- 7. Waterfront Tracts Resubdivision; KPB File 2023-104  
Stantec Consulting Services, Inc. / City of Seward  
Location: Railway Avenue & Lowell Point Road  
City of Seward**

WATERFRONT TRACTS  
RESUBDIVISION

**ITEM #7 - PRELIMINARY PLAT  
WATERFRONT TRACTS RESUBDIVISION**

<b>KPB File No.</b>	2023-104
<b>Plat Committee Meeting:</b>	November 13, 2023
<b>Applicant / Owner:</b>	City of Seward of Seward, Alaska
<b>Surveyor:</b>	John Brady / Stantec Consulting Services Inc
<b>General Location:</b>	City of Seward

Creating Tract: 1A-1, 1B-1 and 2A-1  
Containing ±14.51 Acres  
A Subdivision of:  
WATERFRONT TRACTS MARICULTURE ADDITION, TRACTS 1A  
AND 1B PLAT 97-18 &  
WATERFRONT TRACTS, TRACT 2A  
PLAT 95-13

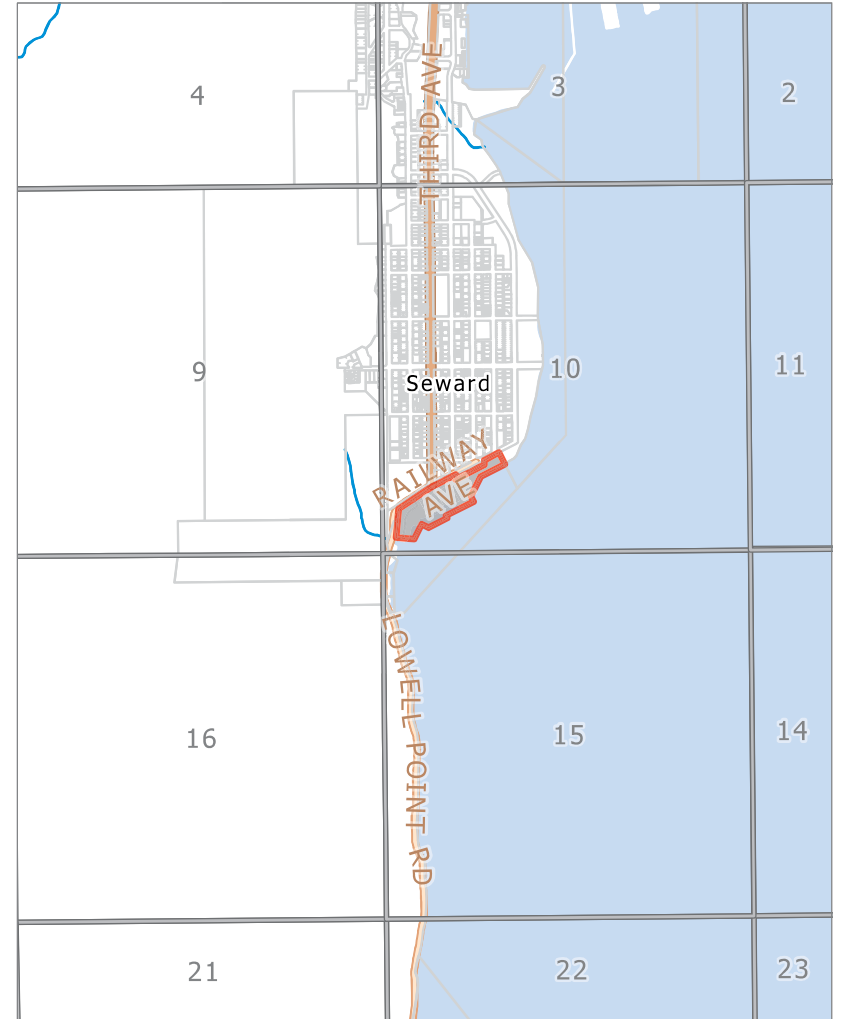
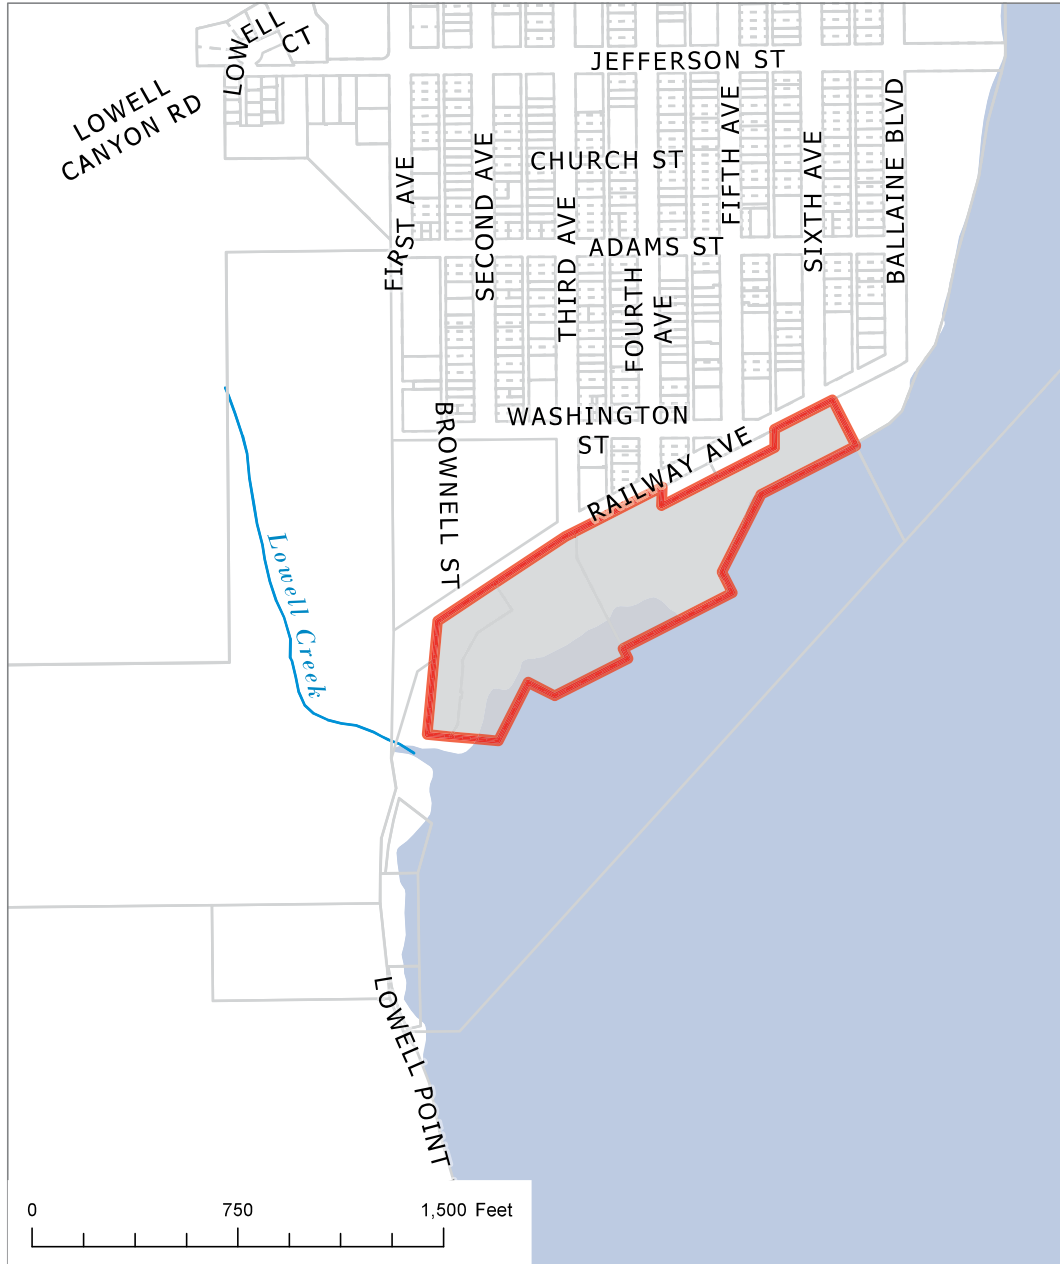
There will be a small portion of existing Tract 1B in the northwest corner of the subdivision being dedicated for right-of-way purposes. This dedication is shown in detail A in a larger view. **Staff recommends:** linework around the dedication be changed to show that it is included as part of the subdivision coming from Tract 1B.

Resurrection Bay is located to the south and per 20.25.070(I) the approximate locations of area subject to tidal inundation and the mean high-water line be shown. **Staff recommends:** *this information be listed on the final submittal and the corresponding note be added as shown under 20.60.110(B).*

- Add KPB File no 2023-104.
- Please correct the entity information and code references within plat note 10. KPB is not the Floodplain authority within the City of Seward.
- On page 1, the measure bearing on the north line near Tract 1B-1 does not match the other bearings along the line at the seconds position.
- The 350.0# in Tract 2A-1 is different between pages.

- Staff recommendation:** Please add width labels for Railway Avenue on the northeast end for clarity. Add width labels for Washington Street, Lowell Point Road, and Ballaine Boulevard.

Detail D  
Preliminary Lease 2  
1" = 20"

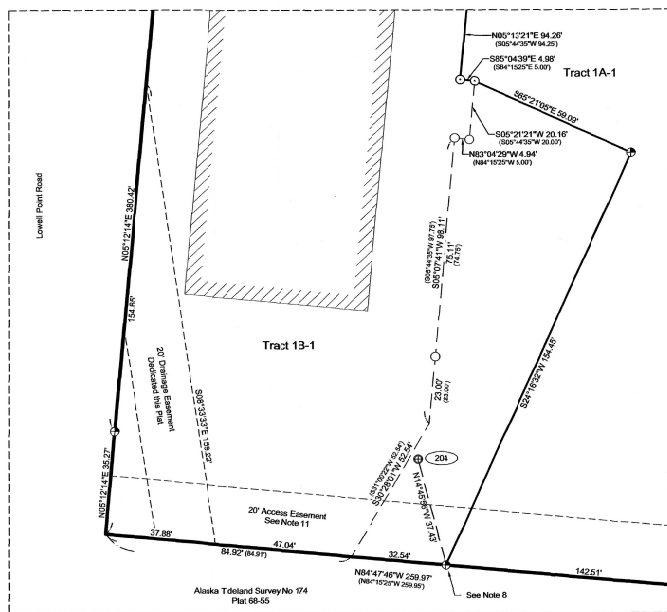
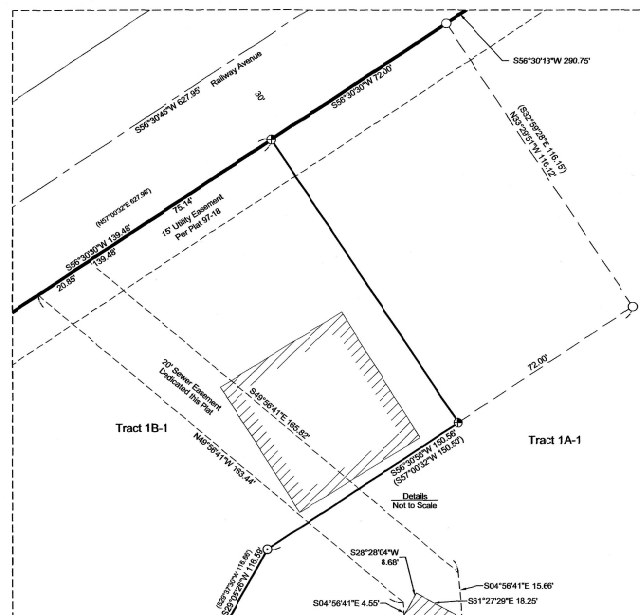
- Staff recommendation:**
- Identify former lot lines on the drawing and details.
  - Right-of-way for dedication is part of subdivision and should be included in dark linework.

- *The borough will not enforce private covenants, easements, or deed restrictions per KPB 20.60.170.*
- *All development must comply with the municipal zoning requirements.*
- *On plat note two, remove the last sentence.*
- *At the end of plat note five add (see Detail B).*
